PLANNING COMMISSION AGENDA

- Final Site Plan Review / C & R Garage LLC / 700 Doheny
- Downs Preliminary Site Plan Review
[Vacant parcels on the south side of Cady St. (between S. Center & Griswold), the Northville Downs racetrack property south of Cady St. (between S. Center and River Streets), and two areas on the west side of S. Center St.]

**Final Site Plan Review
For
City of Northville, Michigan**

Applicant:	C&R Garage LLC 511 W. Main St. Northville, MI 48167
Project Name:	700 Doheny Private Indoor Storage Building
Plan Date:	September 24, 2021
Latest Revision:	March 18, 2022
Location:	700 Doheny (Southeast corner of Doheny and driveway to DPW yard)
Zoning:	PR-2, Performance Regulated Industrial District No. 2
Action Requested:	Final Site Plan Approval
Required Information:	As noted within this review

1 SITE PLAN - PROPOSED
 AS101 1" = 20'-0"

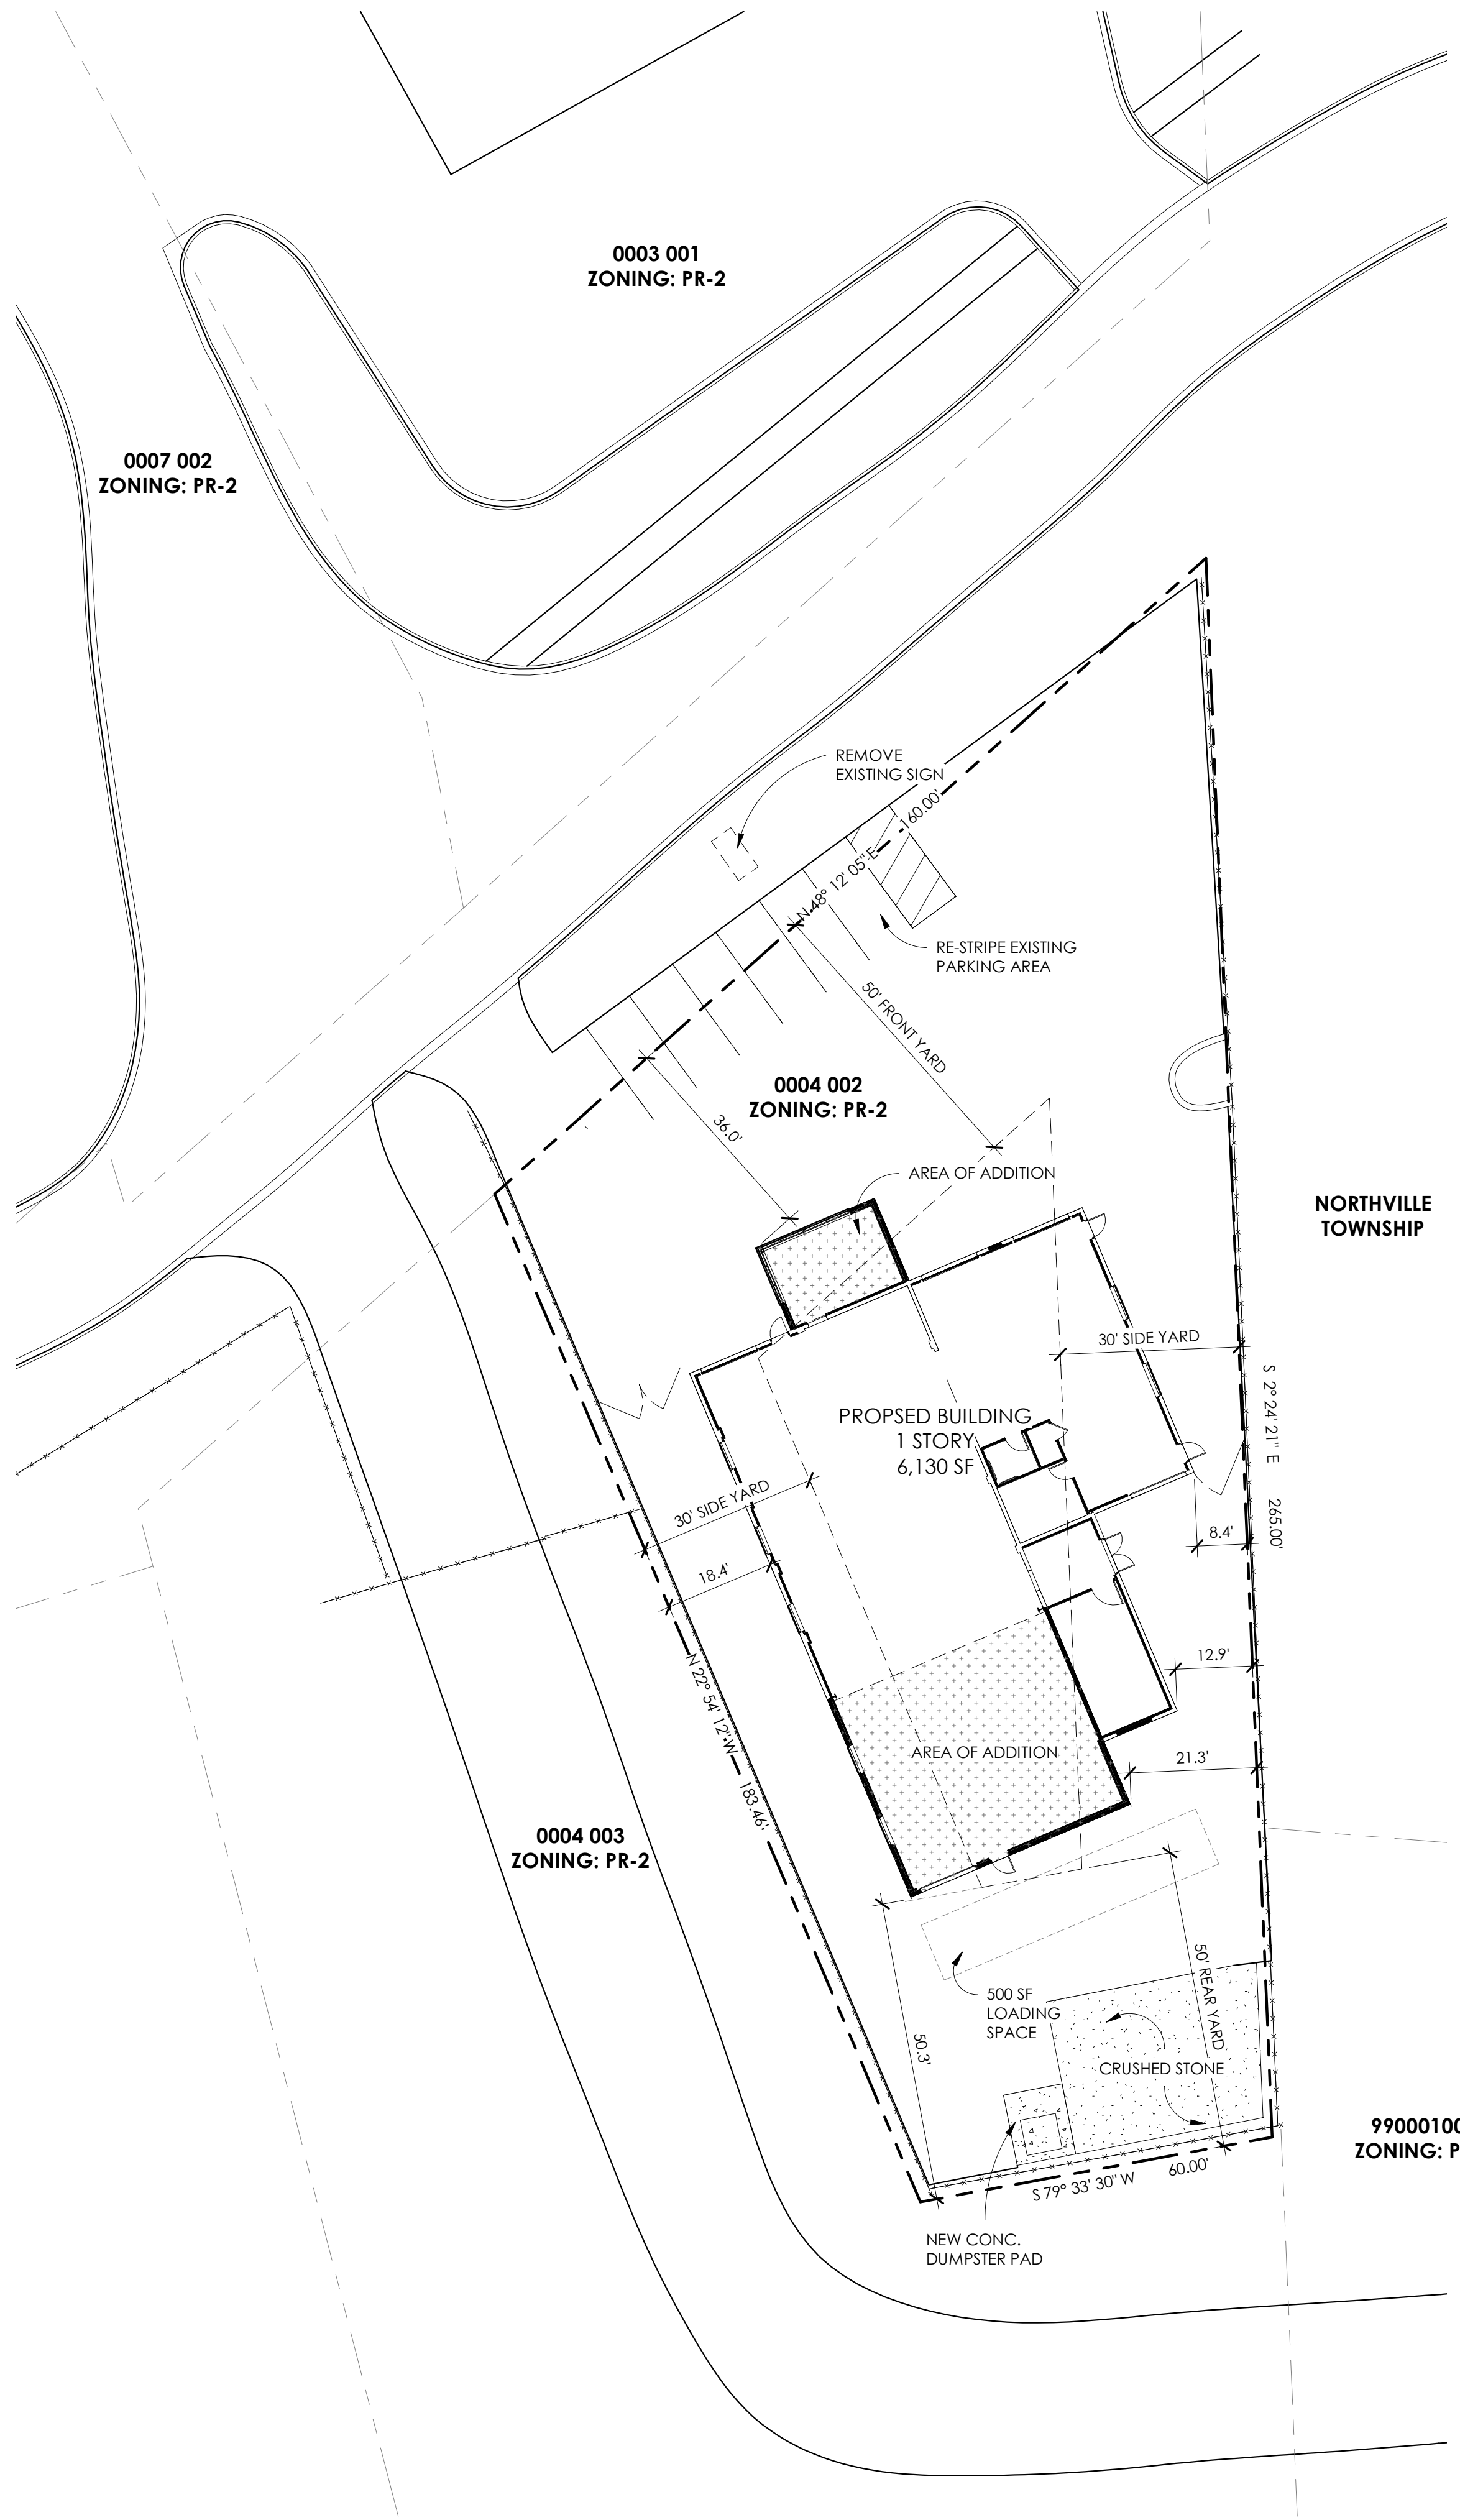
The site plan also shows a proposed dumpster pad at the south end of the site. See our comments regarding the dumpster below.

As required by the Preliminary Site Plan approval, the Final Site Plan shows that the parking spaces in the front of the site will be striped. The striped spaces are located near the front door, which will receive the highest amount of light from the building-mounted light fixtures. The parking spaces and maneuvering lane meets ordinance requirements for size.

The site is accessed from Doheny Dr. from a single, existing driveway. The driveway width is slightly undersized, as it scales on the plans at approximately 17 feet. The minimum width of a driveway in the ordinance is 20-feet. However, this is an existing non-conformity, and we would consider it acceptable for the proposed, private use of the site. As part of the Preliminary Site Plan discussion, the Planning Commission determined that the width of the driveway was an acceptable non-conformity for the proposed use.

The plans show a dumpster pad at the rear of the site. The entire rear of this property is fenced by a chain-link fence that is approximately 3.5-4.0 feet tall. The location abuts the City's DPW yard. As required by the Preliminary Site Plan approval, the dumpster has been moved to the east to be screened from view of Doheny Dr. by the building.

1 NORTH ELEVATION
A-201 1/8" = 1'-0"

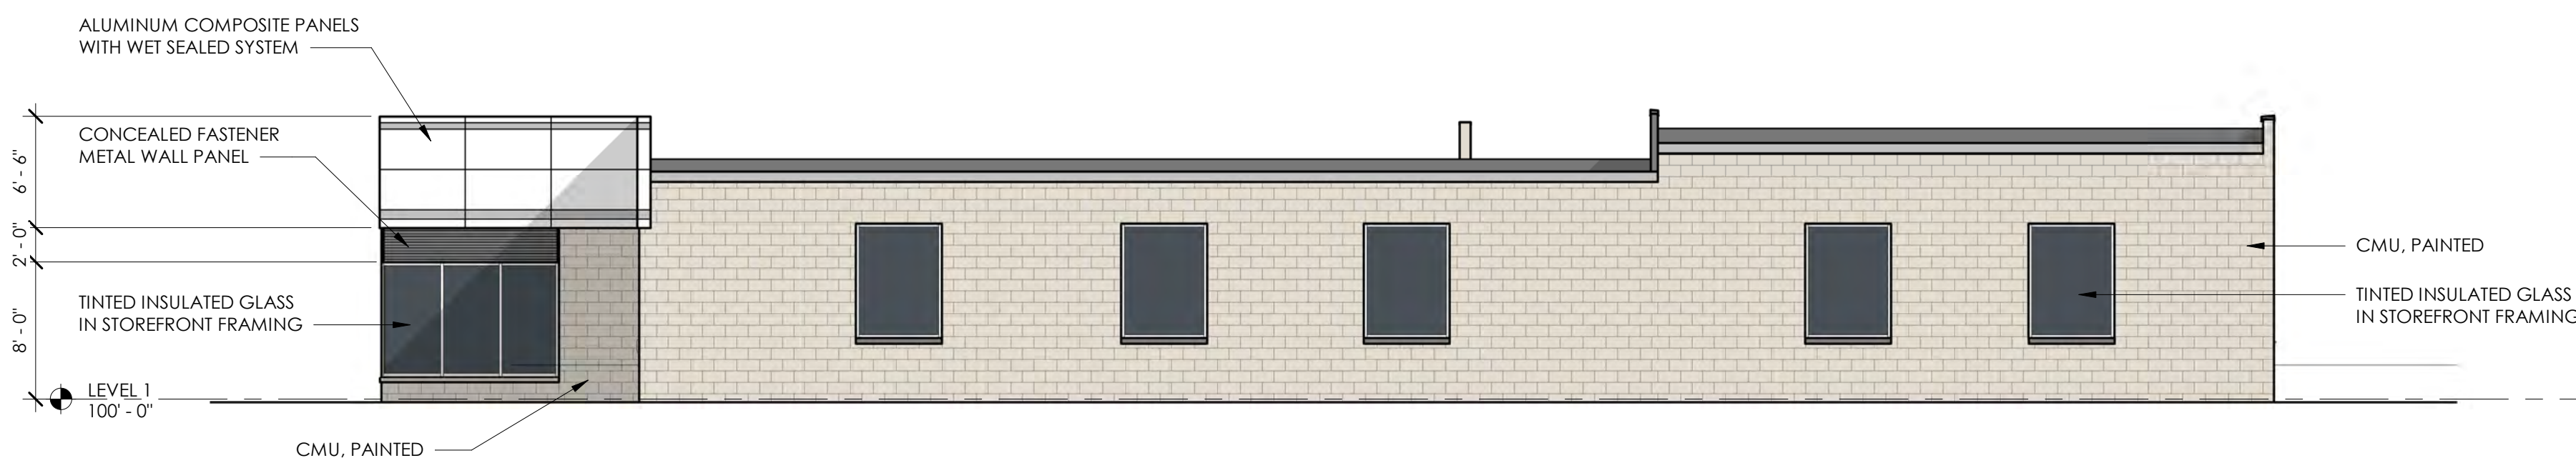
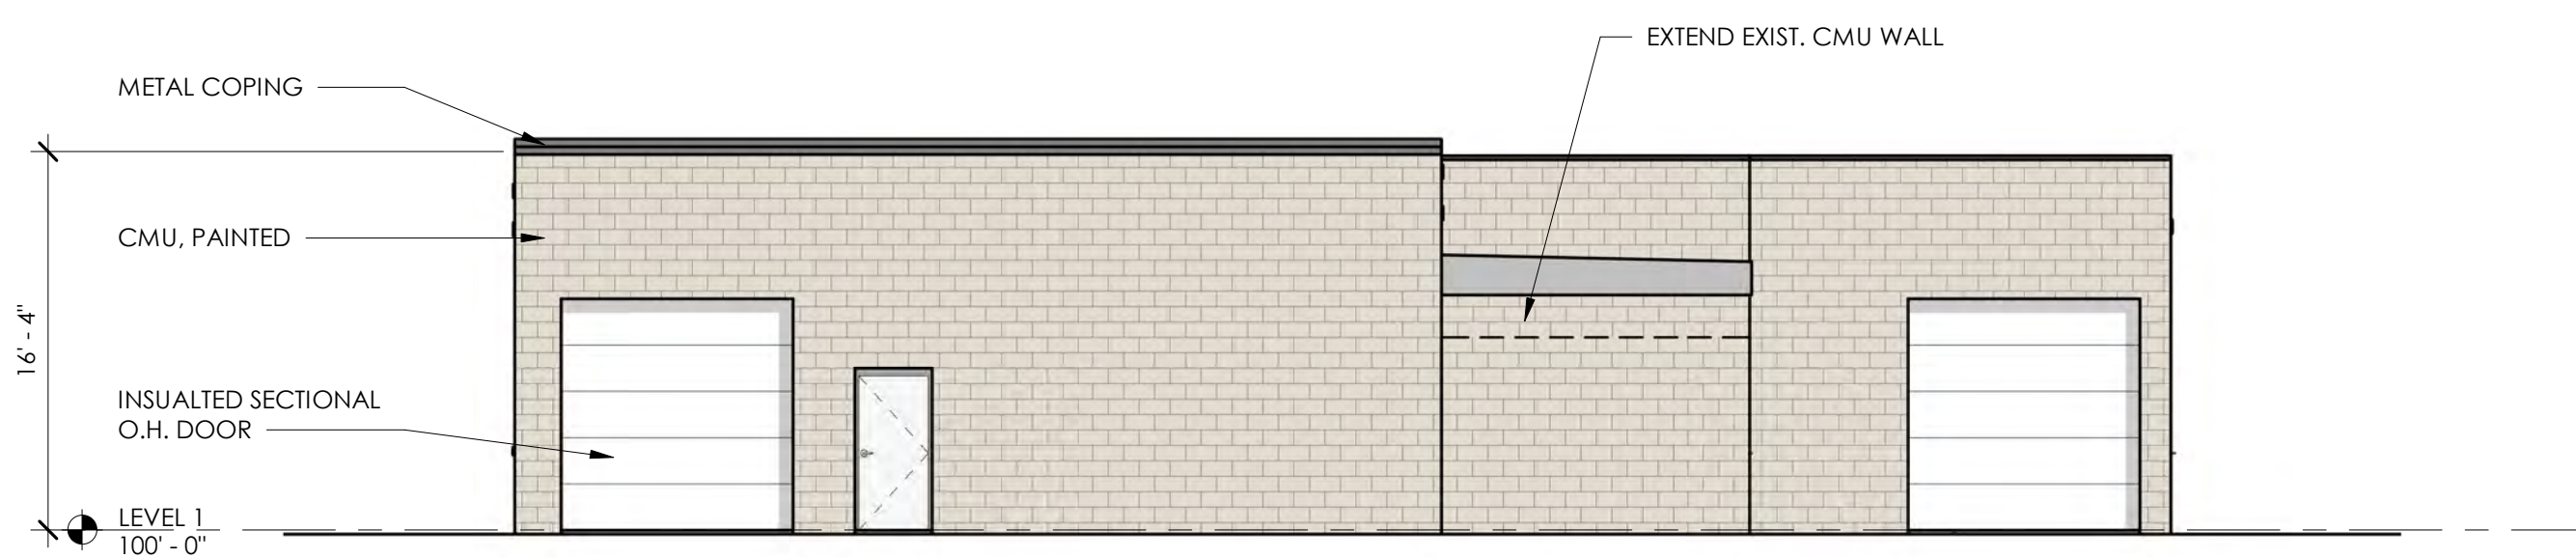
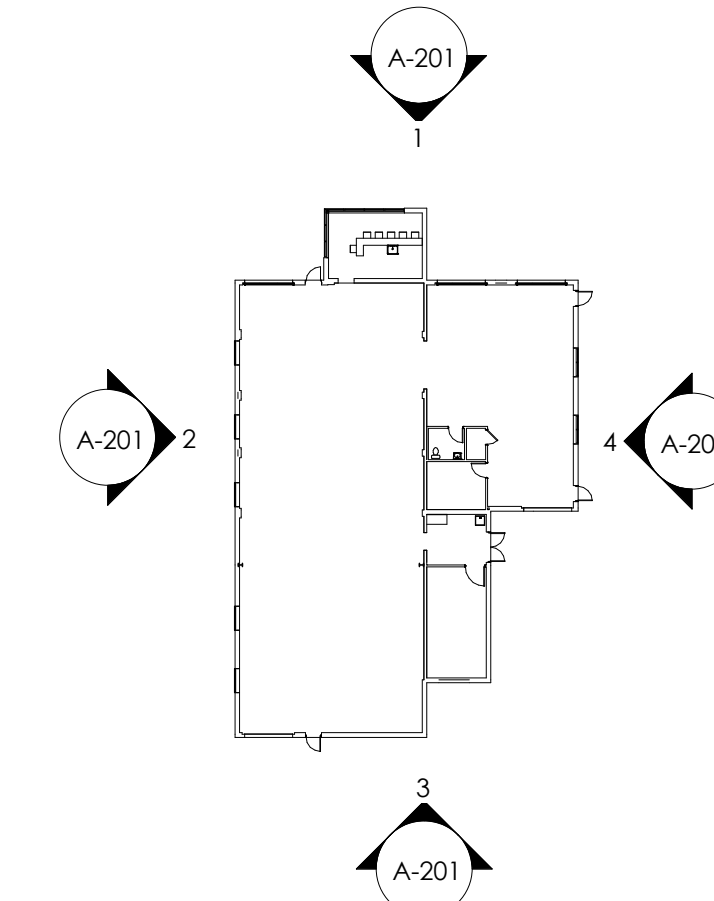
Floor plans and elevations have been provided. The floor plans show a lounge area and laundry area. During the Preliminary Site Plan discussion, the applicant confirmed that the lounge area is meant as a space to sit and/or receive friends and family who may visit the building. It may include a sink, dishwasher, and refrigerator. It will not be used as a party venue. Site visits by friends/family might occur once a month with approximately 10 people or less. No kitchen function or food preparation is planned. They also stated that the building will not be used as a dwelling. The laundry will be used to clean shop rags, per the applicant.

We note that the rear addition on the Final Site Plan is 8-inches shorter than the original plan. This change does not impact the Preliminary Site Plan approval or variances received.

SHEET TITLE
PHOTOMETRIC CALCULATION
SITE

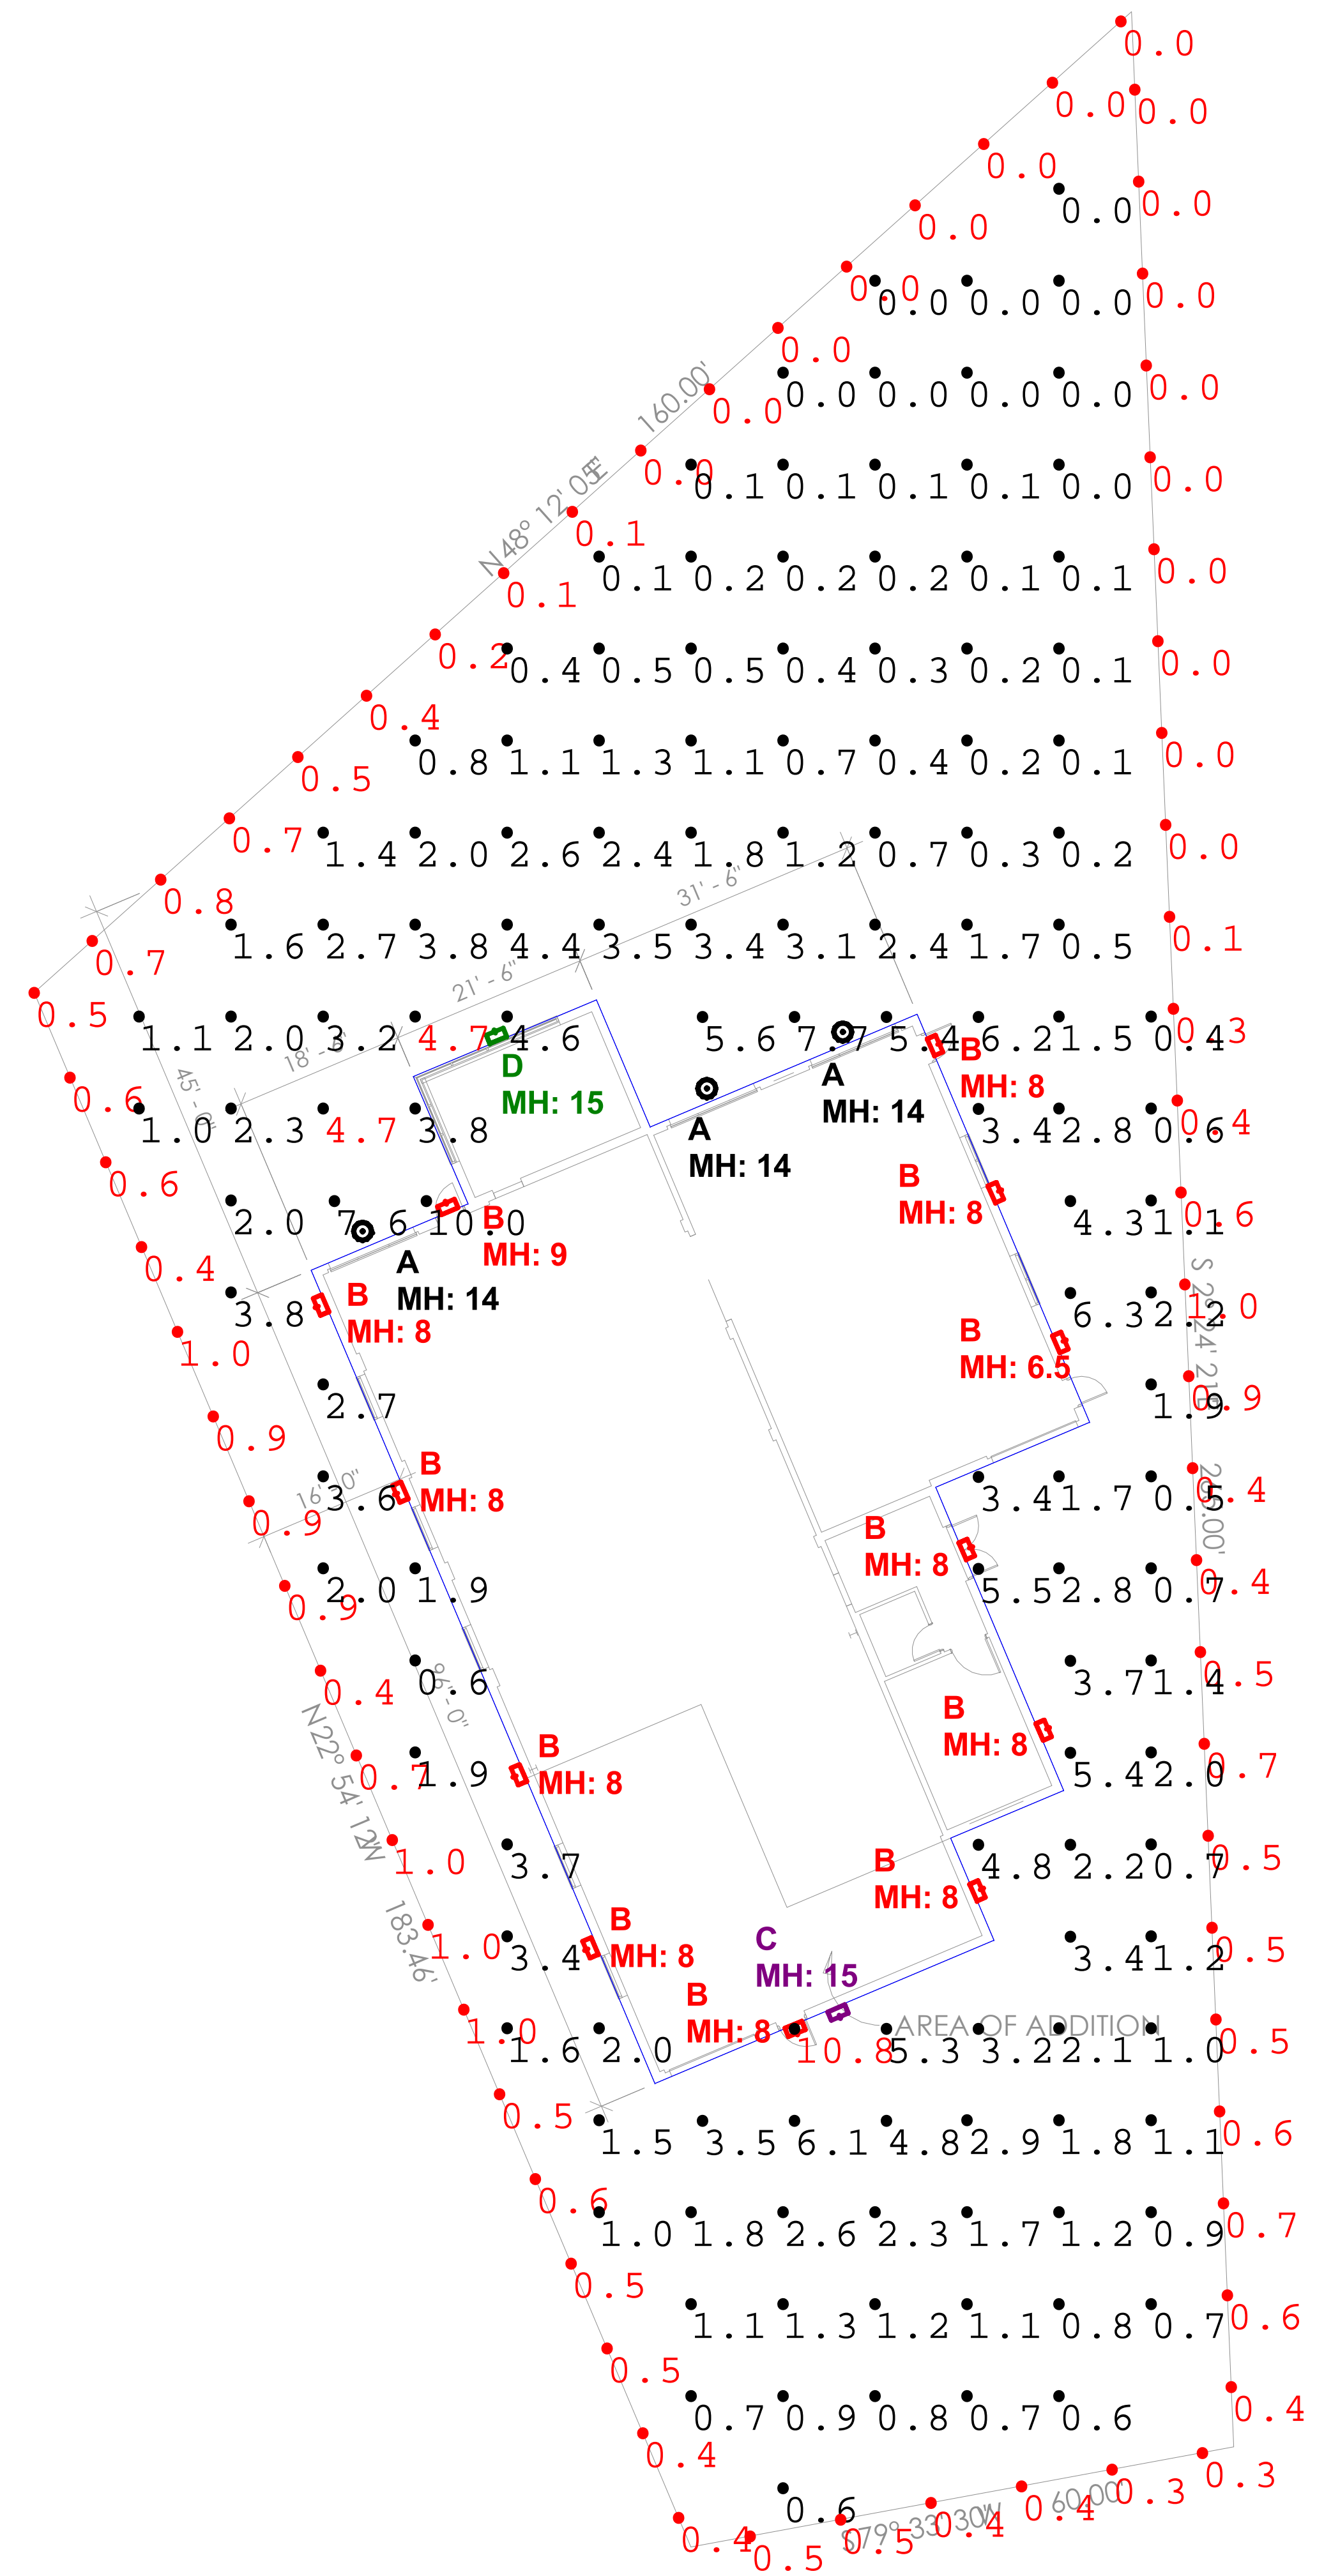
Per the ordinance, all light fixtures shall be shielded or otherwise positioned so that the source of the light does not adversely affect adjacent properties. The adjacent sites are other industrial sites. All proposed fixtures are downward facing. During the Preliminary Site Plan review, the applicant confirmed that the Lumark Axcent fixture is specified with the “full cut-off” option that is fully shielded.

The average footcandle reading at the property line meets the maximum in the ordinance. Also as required by the Preliminary Site Plan approval, the striped parking spaces are located where the parking lot lighting meets the minimum one (1) footcandle reading.
